Subject: MHI's Response to US-APWR DCD RAI No. 288-2274

Reference: 1) "Request for Additional Information No. 288-2274 Revision 1, SRP Section: 03.09.06 – Functional Design Qualification and Inservice Testing Programs for Pumps, Valves, and Dynamic Restraints, Application Section: 03.09.06," dated 3/25/2009.

Responses to Request for Additional Information No. 288-2274,
Revision 1

Figure 2.7.1.9-1 Feedwater System

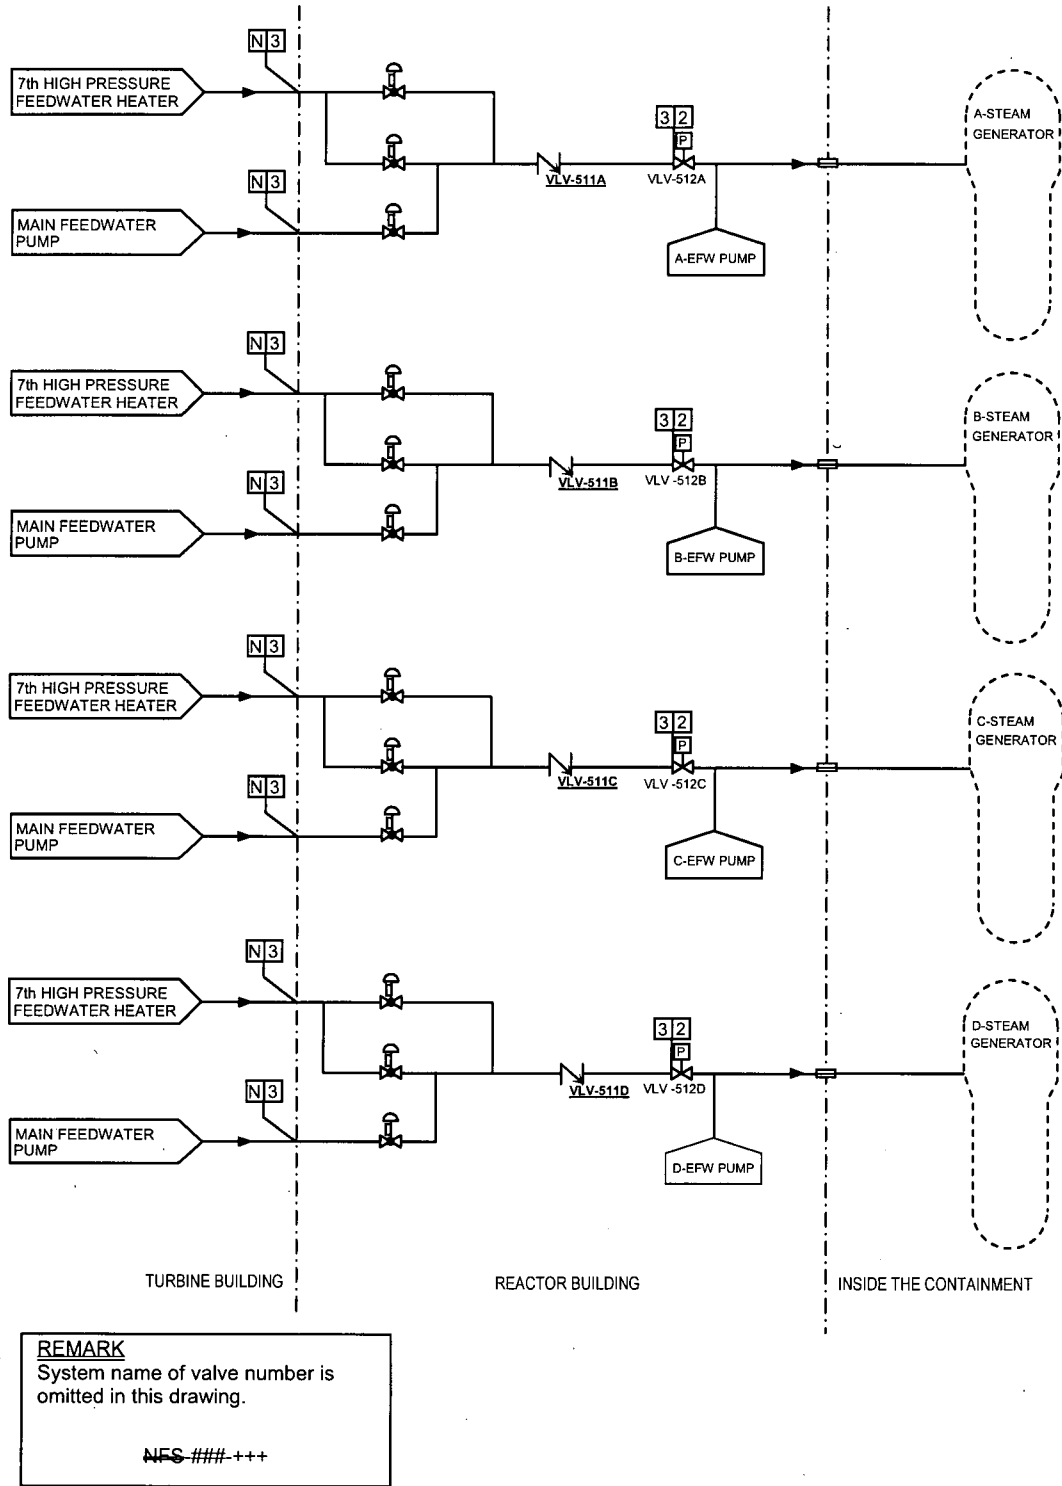
FSAR Figure 10.4.7-1 shows the schematic of the normal feedwater system. Valves NFS-VLV-511A, 511B, 511C and 511D isolate the normal feedwater system from the emergency feedwater system. These valves are not included in the inservice test program yet it appears they are the principle means by which normal feedwater and emergency feedwater are isolated, and diversion of emergency feedwater is possible if these valves do not function as expected. As such, it would appear these valves should be included in the inservice test program as specified by ASME OM Code ISTA-1100. Provide additional information and discuss the function of these valves and why they should not be included in the inservice test program.

US-APWR FSAR Tier 1 Section 2.7.1.9 addresses the condensate and feedwater system. ASME OM Code ISTA-1100 and SRP 3.9.6 Section II Acceptance Criterion 3.A requires the components in the IST program be identified, as well as the performance parameters. Tier 1 Figure 2.7.1.9-1 is the schematic of the normal feedwater system and shows valves NFS-VLV-512A, 512B, 512C and 512D as providing isolation between the normal feedwater system and the emergency feedwater system. Not shown are the normal feedwater check valves NFS-VLV-511A, 511B, 511C and 511D. Isolation of normal feedwater from emergency feedwater is necessary to avoid diversion of emergency feedwater from the steam generators through the normal feedwater system. Provide additional information and discuss how isolation between the two systems is provided, particularly if the normally open manual valves are the credited isolation means. If the check valves are credited, discuss whether they should be shown on the schematic. Discuss the IST requirements for the above valves.

- Add check valves NFS-VLV-511A, 511B, 511C, and 511D in Figure 2.7.1.9-1:

- Refer to RAI 03.09.06-29, Impact on DCD, for addition of check valves NFS-VLV-511A, 511B, 511C, and 511D in Figure 2.7.1.9-1.

Figure 2.7.1.11-1 Emergency Feedwater System

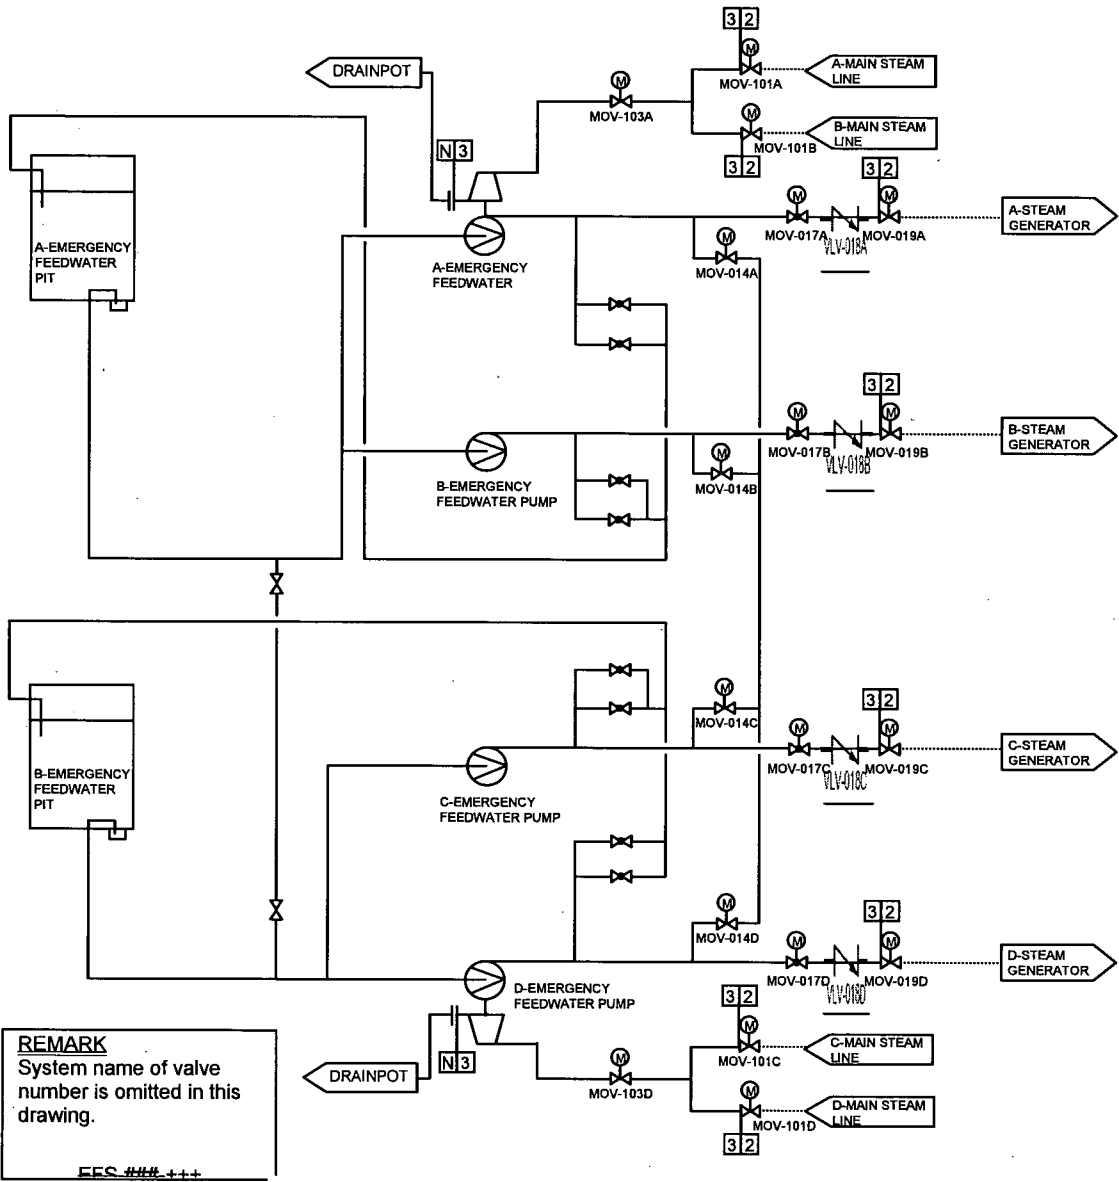
US-APWR FSAR Tier 1 Section 2.7.1.11 addresses the emergency feedwater system. ASME OM Code ISTA-1000 requires that pumps or valves that are required to perform a specific function in shutting down a reactor to the safe shutdown condition, in maintaining the safe shutdown condition or in mitigating the consequences of an accident are to be included in the inservice test (IST) program. Figure 2.7.1.11-1 depicts the emergency feedwater system. Leakage from the steam generators into the emergency feedwater system can potentially disable the emergency feedwater pumps due to voiding and steam binding. Isolation of the emergency feedwater system from the steam generators is therefore necessary. Figure 2.7.1.11-1 does not show an isolation means (check valves) between the steam generators and the emergency feedwater system. Discuss the need for and means of achieving this isolation and whether this information needs to be shown on Figure 2.7.1.11-1. Discuss whether these valves should be classified as category A valves per ISTC-1300.

The answer to RAI 160-1848, Question 10.4.9-20 has previously noted the addition of valves EFS-VLV-018A, 018B, 018C, 018D to Tier 1, Figure 2.7.1.11-1. The valves EFS-VLV-018A, 018B, 018C, 018D are classified as Category B, as discussed in the response to RAI 03.09.06-30.
